**Refuse Deflector Installation for  
McNeilus or Agility 75 DGE CNG Roof  
Mounted Systems**

**Date:** January 2, 2018  
**Bulletin Name:** FEL-TSIB-053-A  
**Model:** Contender FEL 87  
**Model Year:** 2011 - 2017  
**Units Affected:** McNeilus or Agility CNG Roof Mounted Systems

Figure 1

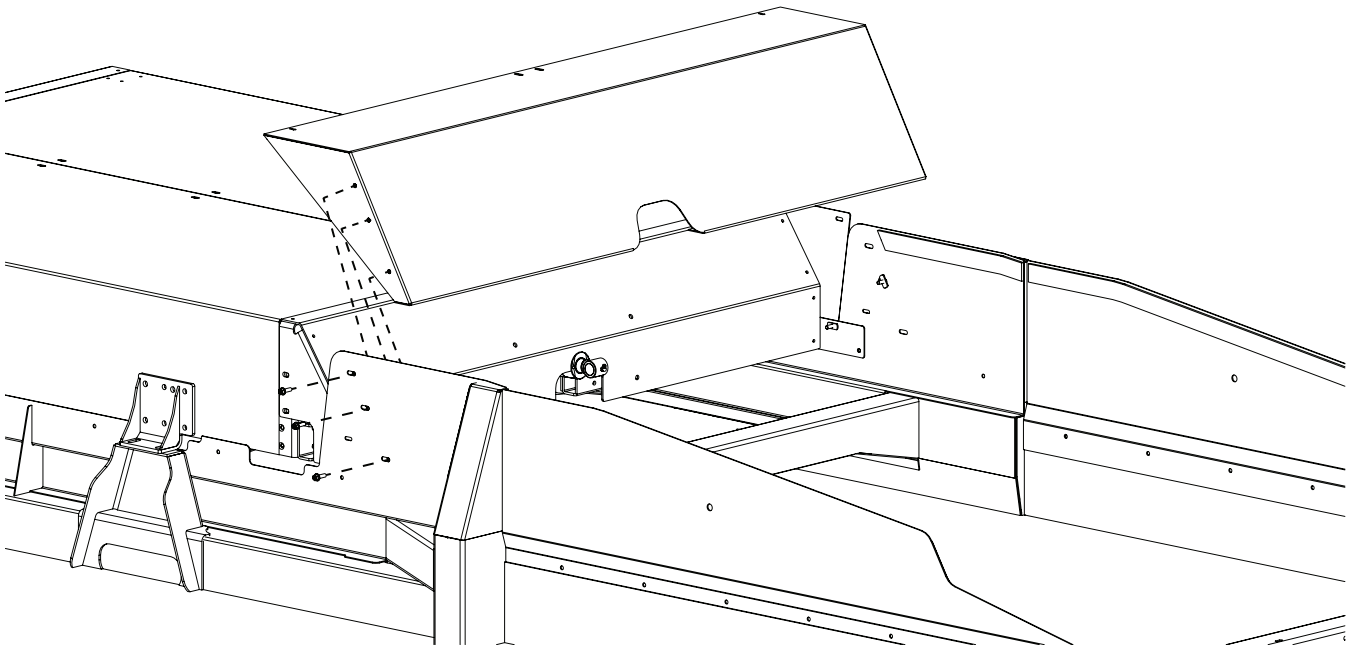
3. Remove and discard the existing deflector and hardware from both sides (Figure 1).

Figure 2

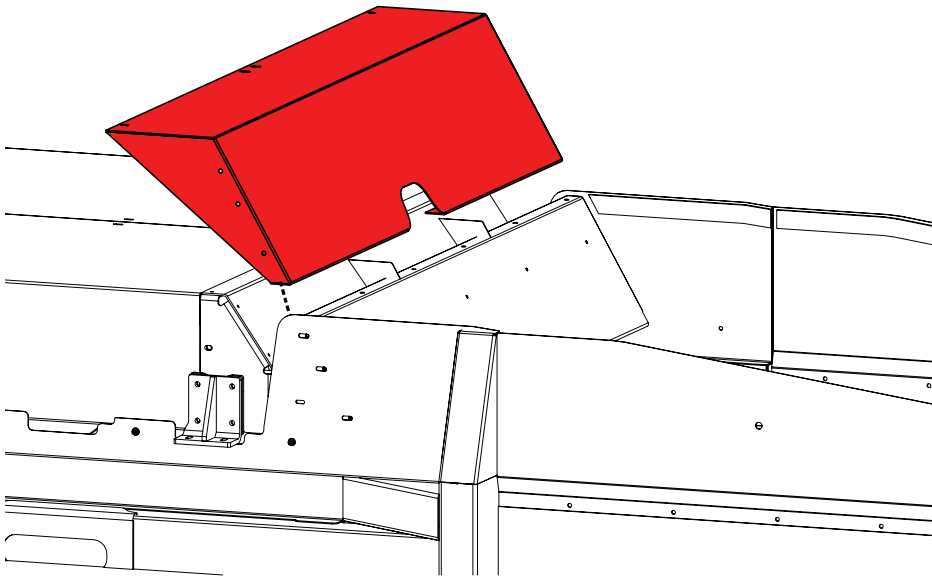
5. Move the refuse deflector weldment (Figure 2) into position at the roof mounted CNG system and align the deflector weldment so that you can install bolts in the three diagonal bolt slots on either side of the vehicle.

Figure 3

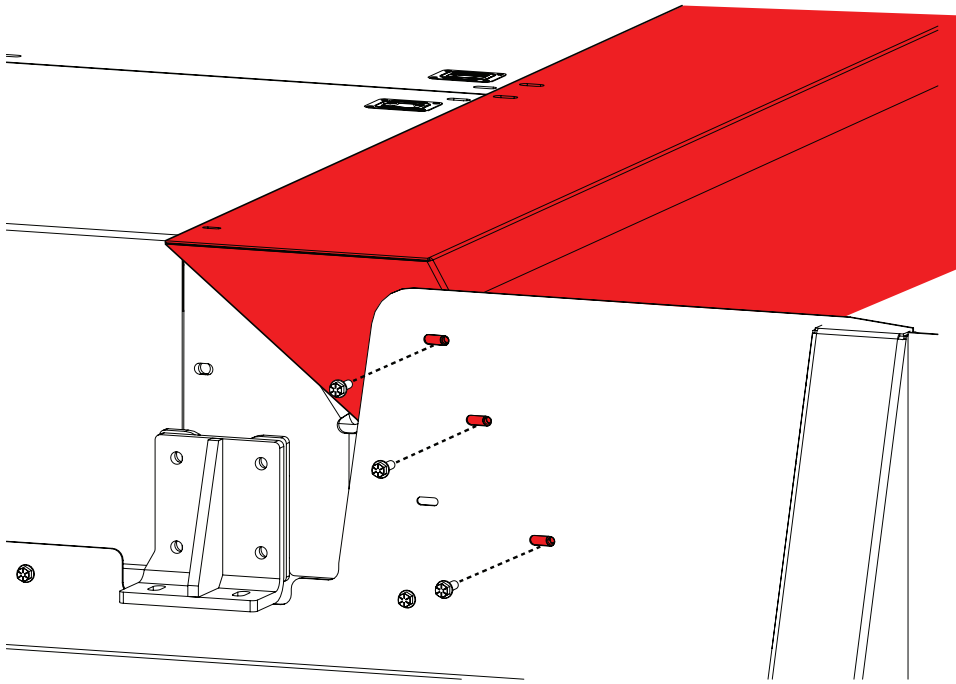
6. Install (3) bolts (PN 1243637) to attach the weldment to the vehicle windguard (Figure 3).

7. Use a torque wrench to torque bolts to 33 ft.-lbs.
8. Repeat Steps 6 and 7 on the opposite side of the vehicle.
9. Install the correct bolts across the top of weldment cover piece. The number of bolts and specific holes used will be based on if the CNG system is McNeilus or Agility. Figure 4 (McNeilus) and Figure 5 (Agility) detail the specific holes for each system.
  - McNeilus CNG system = Bolts PN 0120023, quantity 5
  - Agility CNG system = Bolts PN quantity 1243637, quantity 4
10. Use a torque wrench to torque each McNeilus bolt to 9 ft.-lbs.
  - Use a torque wrench to torque the Agility bolts to 23 ft.-lbs.
